Staff Report
Lake Stevens Design Review Board
Meeting Date: December 14, 2016

FILE NAME/NO: Eagle Glen North Subdivision (LU2016-0138)
APPLICANT: H. George Newman, AICP / Barghausen Consulting Engineers
LOCATION OF PROPERTIES: 1425, 1429, 1431 and 1433 99th Avenue SE, Lake Stevens, WA 98258
ASSESSOR PARCEL NUMBER(S): APNs 00493401800300, 00493401800301, 00493401800302 and 00493401800303
REQUEST: Design Review Approval of Subdivision
CONTACT PERSON: Stacie Pratschner, Senior Planner

PROJECT DESCRIPTION

Exhibit 3e

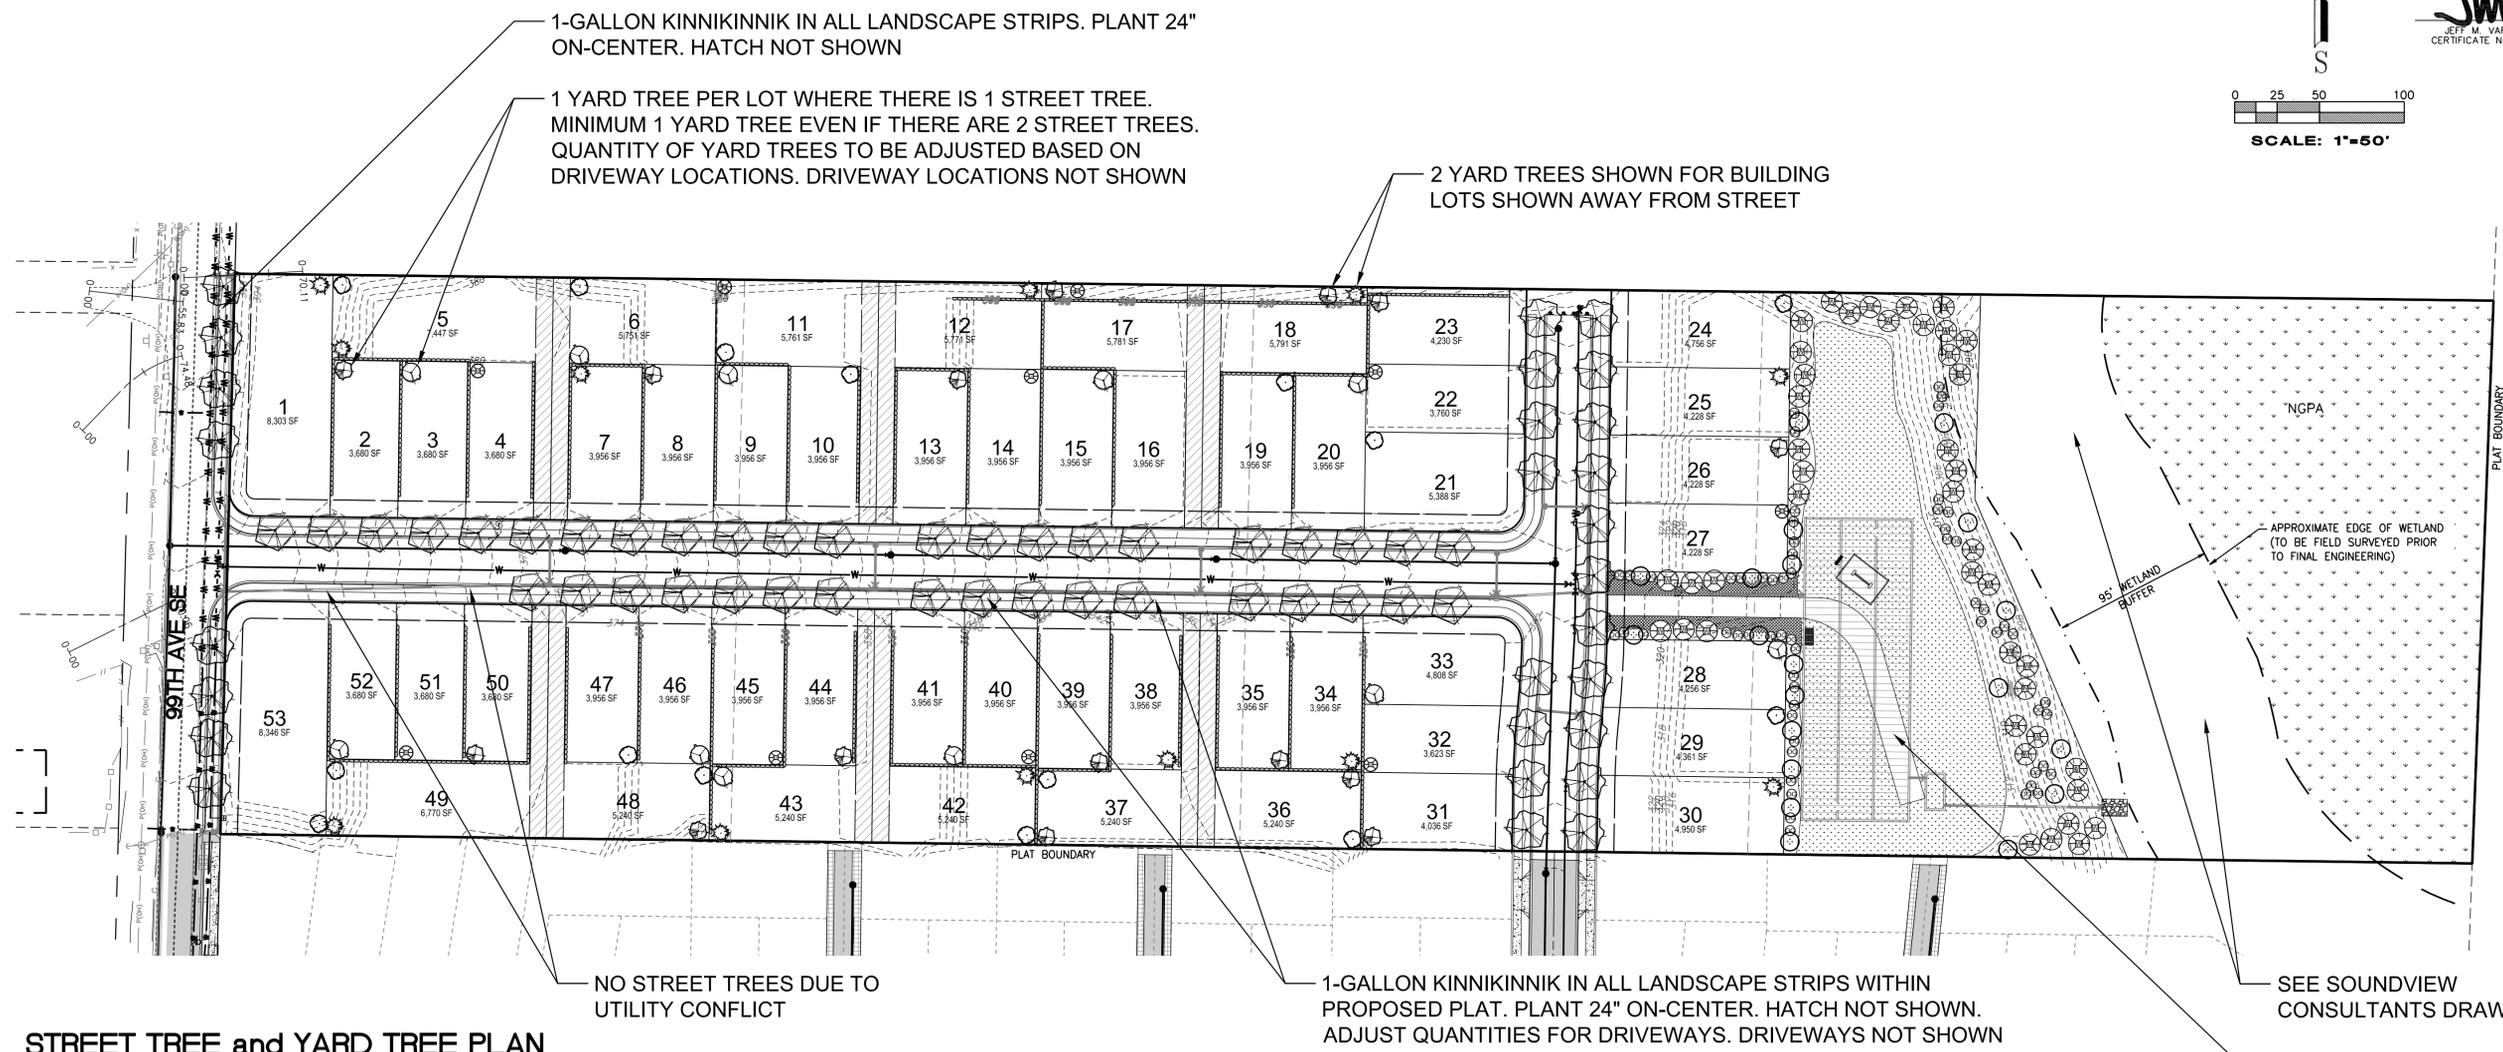
Findings: The landscape plans (Sheets L1 through L3 of **Exhibit 3e**) show the proposed planter strips, street trees and buffer enhancement pursuant to the frontage improvements and the recording of the NGPA. The applicant has also submitted photographs of the proposed plantings indicating the types of vegetation that will be used throughout the development (**Exhibit 3f**).

Findings: Street trees will be installed as required by LSMC section 14.76.110. The applicant is proposing the drought tolerant species of Pacific Sunset Maple and Autumn Applause Ash. The species and installation of these trees will be reviewed during Construction Plan review.
